SERVICE BULLETIN

#0027

SUBJECT: Interference of TSi firewall cutout and left nose gear pushrod

Figure 3

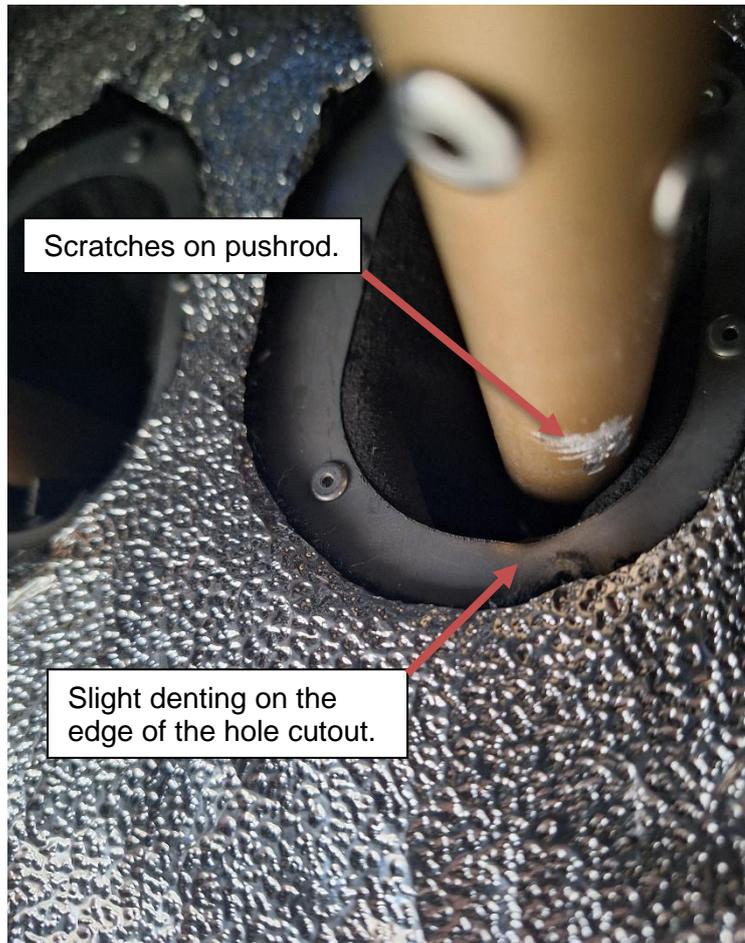
It is possible to inspect the nose gear pushrod without removing the cowling. Inspect the pushrod and look for any scratches as well as denting along the edge of the firewall cutout. Refer to Figure 3 on what this will look like. If this is present on the aircraft, the clearance between the pushrod and the hole cutout will need to be increased. Refer to Section 3.2 for the instructions on how to do this.

Figure 5

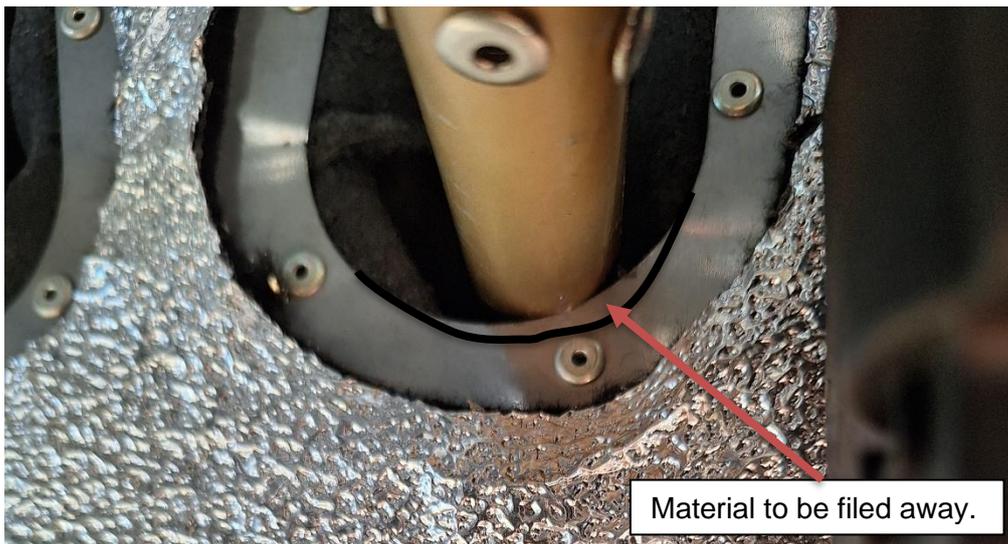
- Step 1: Remove the cowling, this will make it easier to access the pushrod and the cutout. Refer to Section 5.1.1 of the Sling 4 TSi Maintenance Manual (DC-MAM-001-X-F) for instructions on how to remove the cowling.
- Step 2: Using the marker pen, mark the area of the cutout that is to be filed down, this is where the pushrod makes contact with it. The profile of the curve should be a gentle radius, so that there will not be any sharp corners once the area has been filed down. Refer to Figure 5. Only do this for the cutout of the left pushrod, the right one is not affected by this interference. Alternatively, the template located at the end of this document may be used to mark the profile that the hole should be widened too.

- Step 3: Use the 1/2" and 7/16" spanners to loosen the lock nuts on the affected pushrod, and then remove the pushrod.
- Step 4: Using a metal file, file down the affected area around the firewall cutout.
- Step 5: Once complete, reinstall the pushrod. Ensure that when the rudder pedals are extended fully right, the pushrod does not contact the edge of the cutout. If required, file down the edge further.
- Step 6: Ensure full and free movement of the rudder pedals.
- Step 7: Lock the nuts on the pushrod's rod ends and apply torque seal.
- Step 8: Reinstall the cowling.

Figure 7

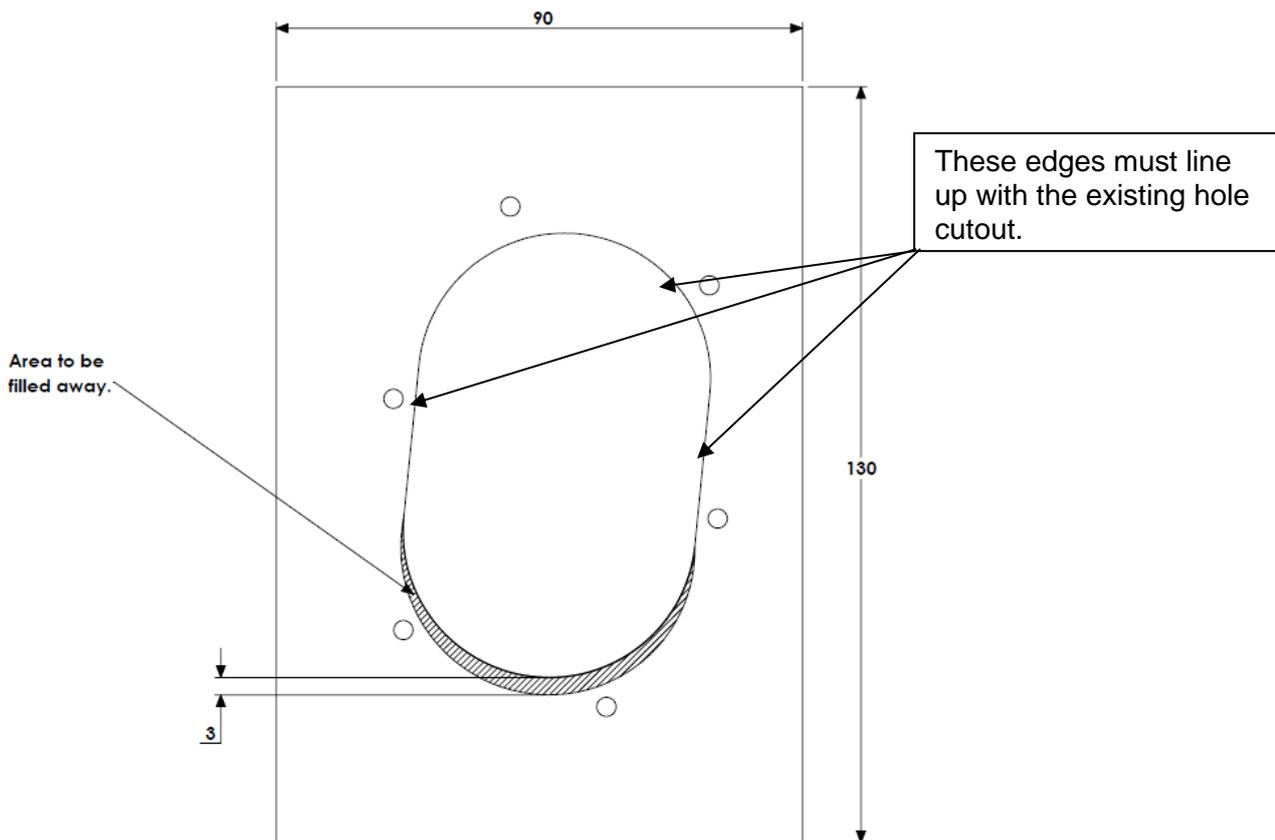
- Step 2: Cut out the provided template from the page.
Step 3: Line it up with the cutout on the firewall. Masking tape can be used to hold the template in place if required.

- Step 4: Mark the widened profile.
Step 5: Using a metal file, file away the required material around the hole cutouts edge.
